Agenda  
Village of Glen Ellyn  
Special Meeting  
Monday, December 18, 2017  
7:00 PM  
Glen Ellyn Civic Center, Room 301

**H. Taylor Avenue Pedestrian Tunnel Project (Professional Engineer Daubert) (Trustee Kenwood)**

**1. Motion to increase the appropriation for Phase II engineering services associated with the Taylor Avenue Pedestrian Tunnel Project provided by Alfred Benesch & Company in the amount of \$34,105 for a revised total appropriation of \$189,565 to be expensed to the Capital Projects Fund. 2. Motion to authorize the Village Manager to execute Change Order No. 2 to the Phase II engineering services agreement with Alfred Benesch & Company for the Taylor Avenue Pedestrian Tunnel Project for additional investigations and analyses in the amount of \$34,105 resulting in a revised total fixed price of \$189,565.**

**From:** O'Connor, Michael  
**To:** [Richard Daubert](#)  
**Cc:** [Keaschall, Andrew](#)  
**Subject:** Village of Glen Ellyn Taylor Ave. - Supplement to Address New Conditions  
**Date:** Thursday, December 07, 2017 10:13:06 AM  
**Attachments:** [10507 - Glen Ellyn Scope Change Spreadsheet.pdf](#)  
[Glen Ellyn Scope Change Attachment Exhibits.pdf](#)  
[

Exhibit 5

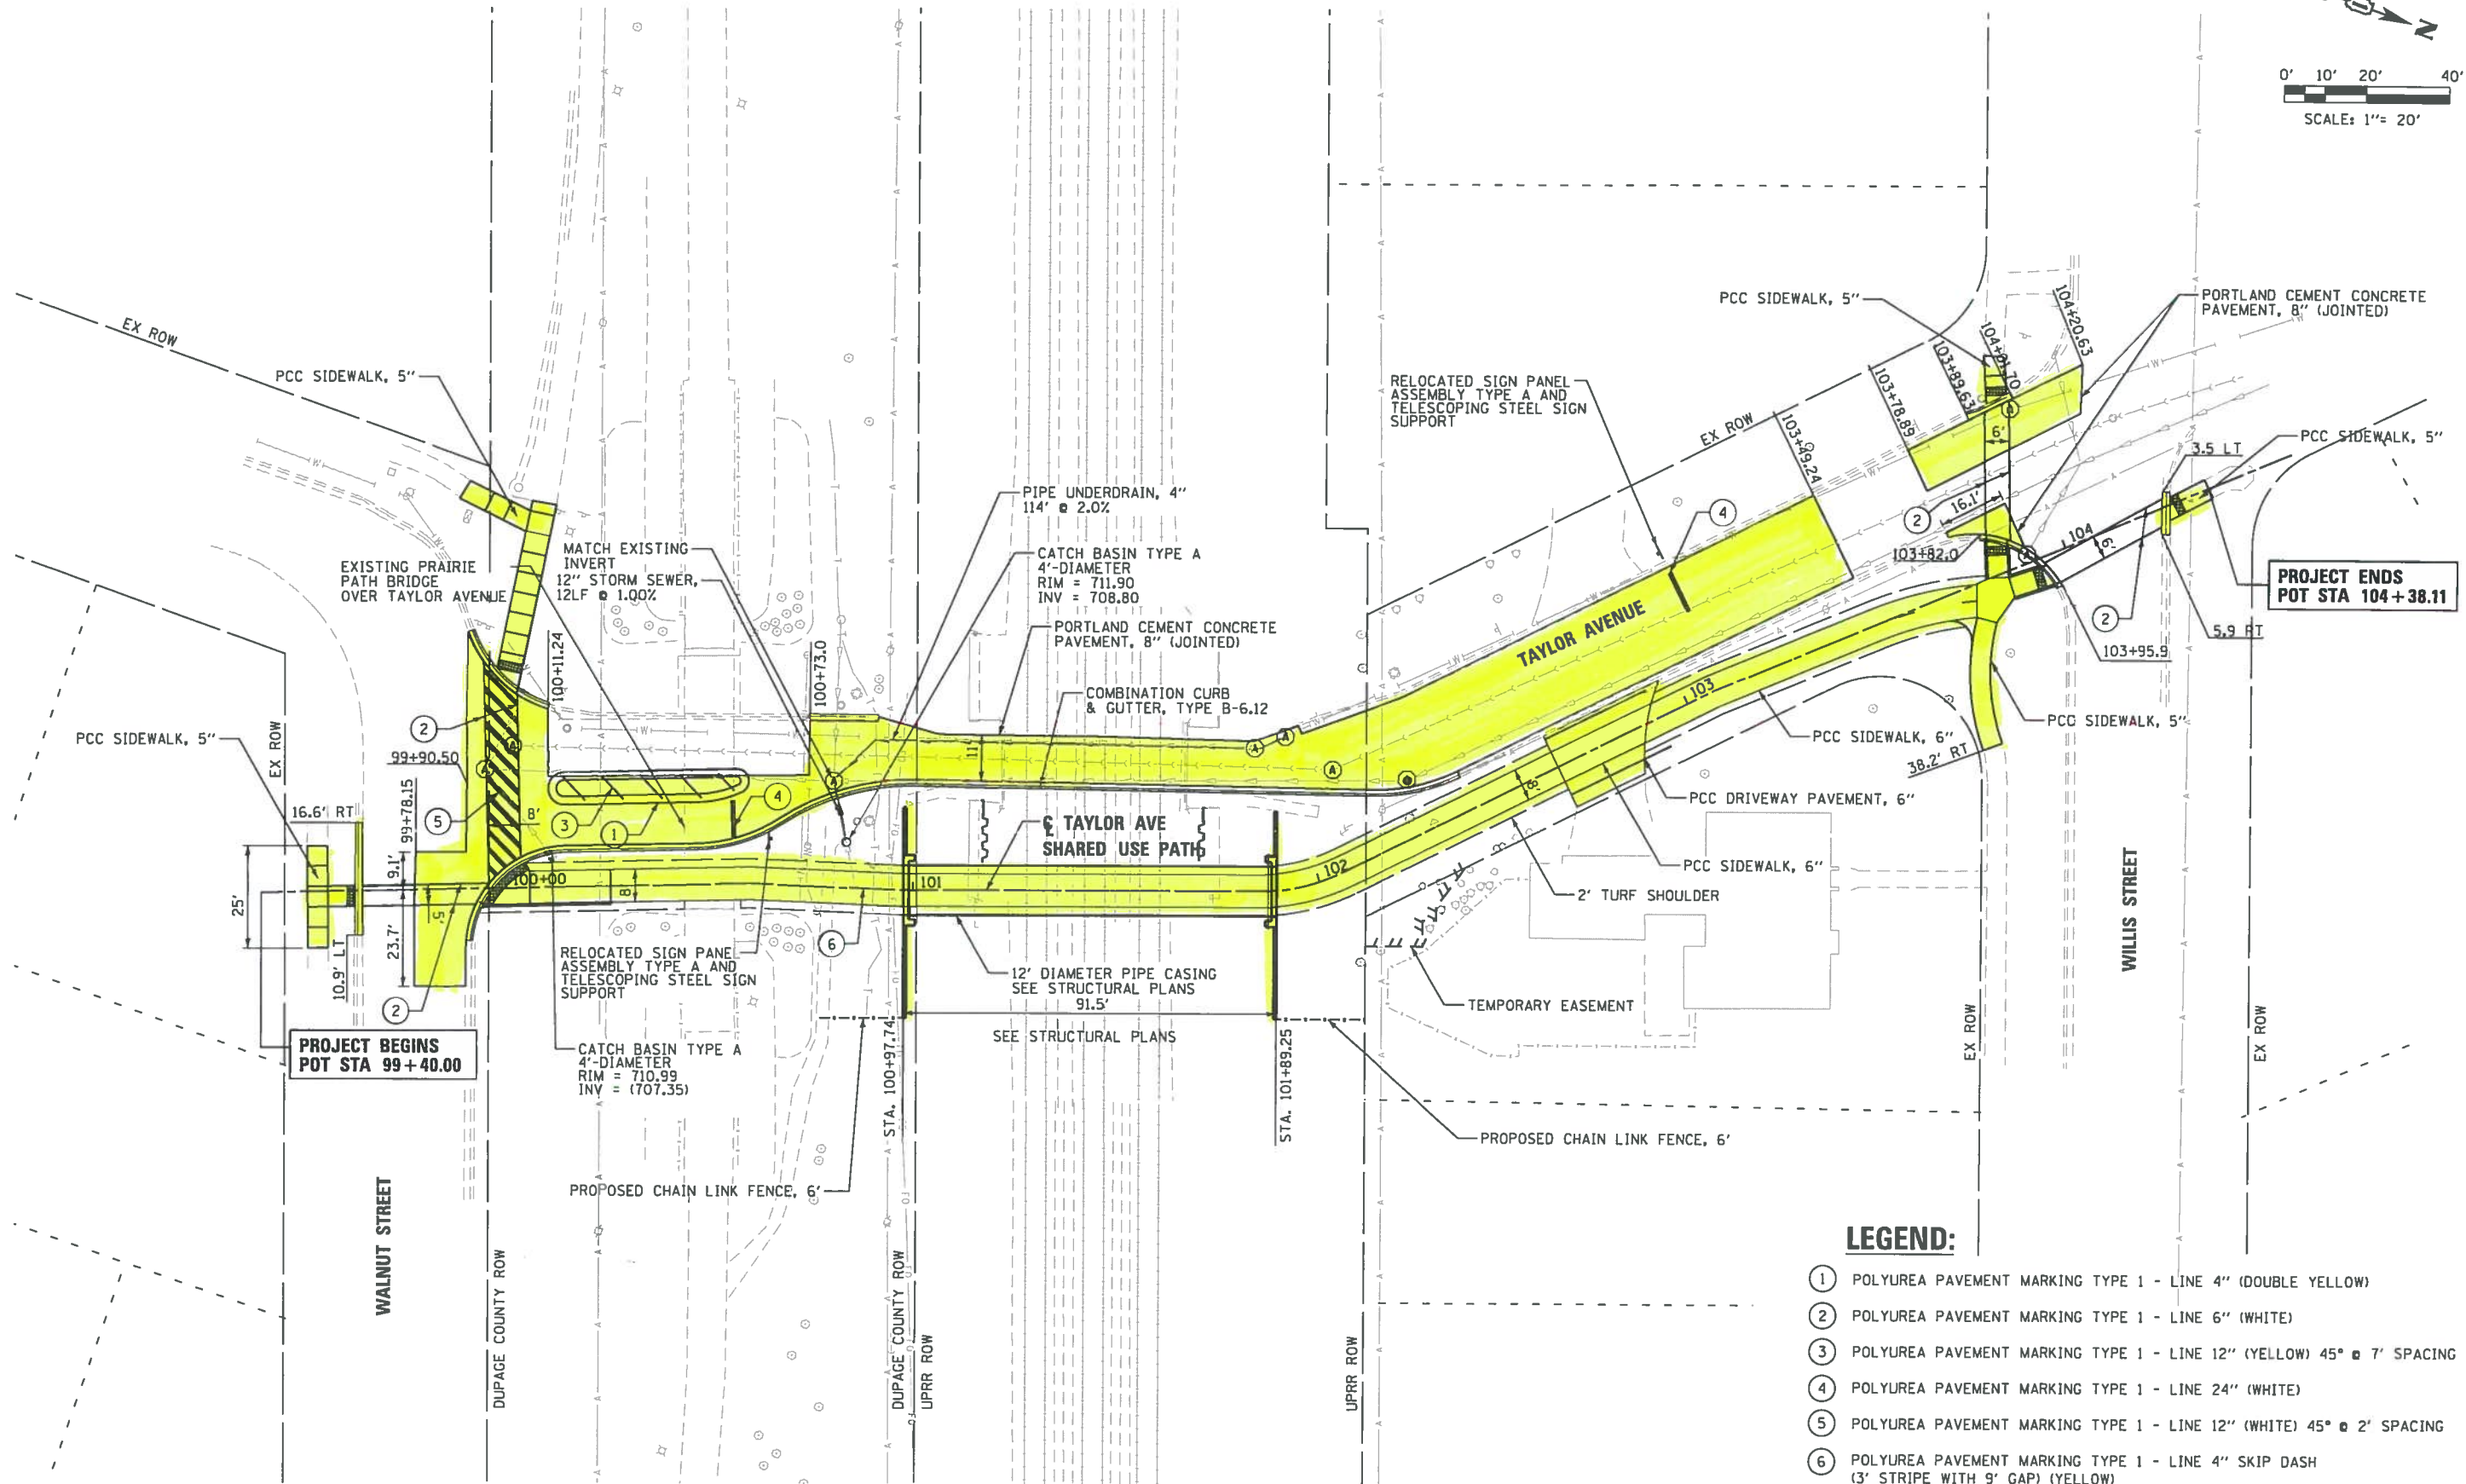
- a. Per Agreement Provision I.13 in the Phase II Engineering Services Agreement for Federal Participation, the “plans, specifications and estimates shall be in accordance with the scope of improvements as identified in the Phase I Project Development Report.” Design Approval was received based on the configuration documented on the Plan and Profile in Appendix B of the Project Development Report (pavement reconstruction only in area surrounding the sidewalk removal within the Taylor Avenue underpass beneath the UPRR, traffic signal & underpass lighting).

- b. The changed condition consisted of the Village requesting additional pavement reconstruction not included in the limits outlined in the PDR. This change affected Civil and Electrical plans and quantities due to the replacement of the detector loops located in the pavement. The Village also requested additional electrical work (inclusion of additional street lighting and foundations). These changes in scope required the addition of a 4 plan sheets and the associated 10 quantities and specifications. The change in scope of the project from Phase I to Phase II final plans is presented in Exhibit 5.<sup>1</sup>
